APPLICATION FOR CERTIFICATE OF APPROPRIATENESS

1028 Luttrell St. 37917

Staff Report

File Number: 9-F-24-HZ

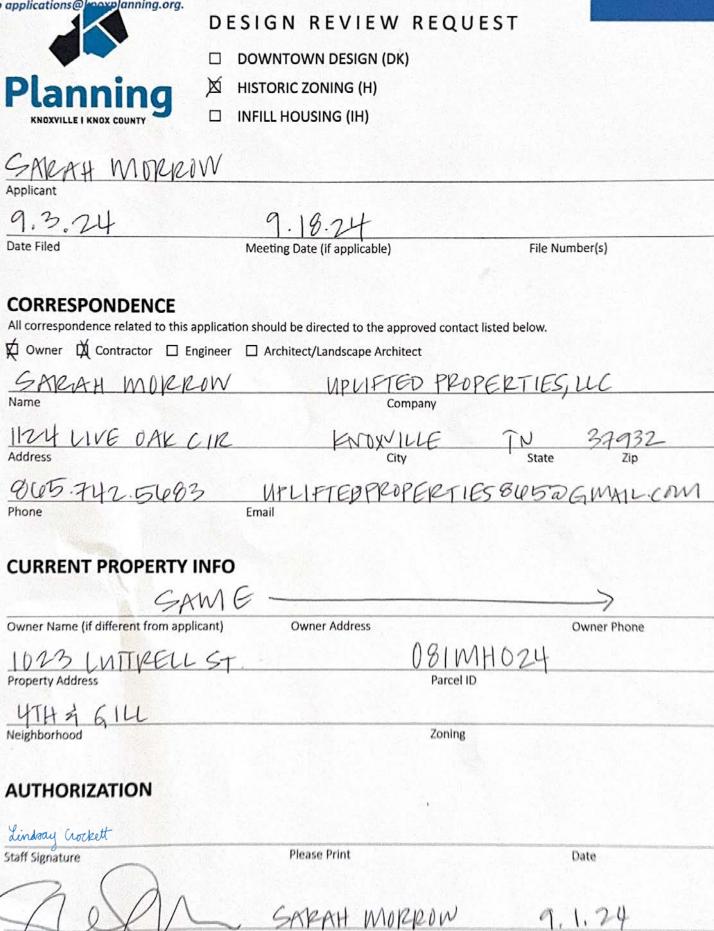
- 1. 1028 Luttrell Street is a contributing resource to the Fourth and Gill NR district and the local overlay. The house has experienced a significant amount of deferred maintenance, leading to deteriorated windows, foundation, siding, and roofing.
- 2. The rear addition to be removed is a non-historic enclosed porch, resting on a deteriorated, non-code compliant foundation, of which the City Plans Review and Inspections would not permit rehabilitation. Demolition of the rear addition is appropriate.
- 3. The new one-story, gable-roof rear addition is proportionate to the primary house. On the left side elevation, the addition will extend approximately 17' from the main massing of the house, an additional 10' from the existing rear addition. Due to the adjacent vacant lot, the left elevation of the addition will be visible from the right of way. The

addition has been revised to include one window to contribute additional transparency to a large swath of siding. The addition has also been revised to be inset 6" from the primary house.

GAF GAF Weatherside Rounded Fiber Cement Woodgrain Shingle Siding Panel Pre-primed White 32-in x 9-in Item #805144 | Model #2214000WG

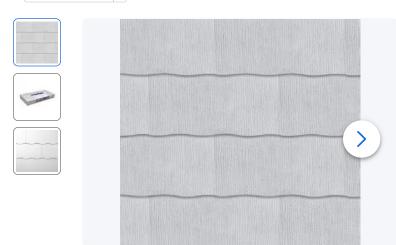
- 6. The applicant intends to retain the existing asbestos shingle siding wherever possible. Due to the unavailability of new asbestos shingles to patch, the application proposes new textured fiber cement shingles to patch the existing and on the new addition. In the opinion of staff, the limited patching of fiber cement shingles, especially on less visible elevations where the siding deterioration is most significant, is appropriate within the guidelines. The existing asbestos shingles most likely date to the 1940s or 1950s, are expensive and challenging to remove, and can be patched. The fiber cement shingles should be confirmed to match the asbestos shingles in size, thickness, and visual detail.

- 1) for any windows which cannot be repaired, specifications should be submitted to Commission for review and approval in a new application;
- 2) exterior window trim to be repaired and/or replaced in-kind;
- 3) new fiber cement shingles to match existing asbestos shingles in size, thickness, and detail, with measurements provided to staff;
- 4) new porch flooring to use tongue-and-groove wood instead of decking;
- 5) front porch railing detail to be submitted to staff for review.
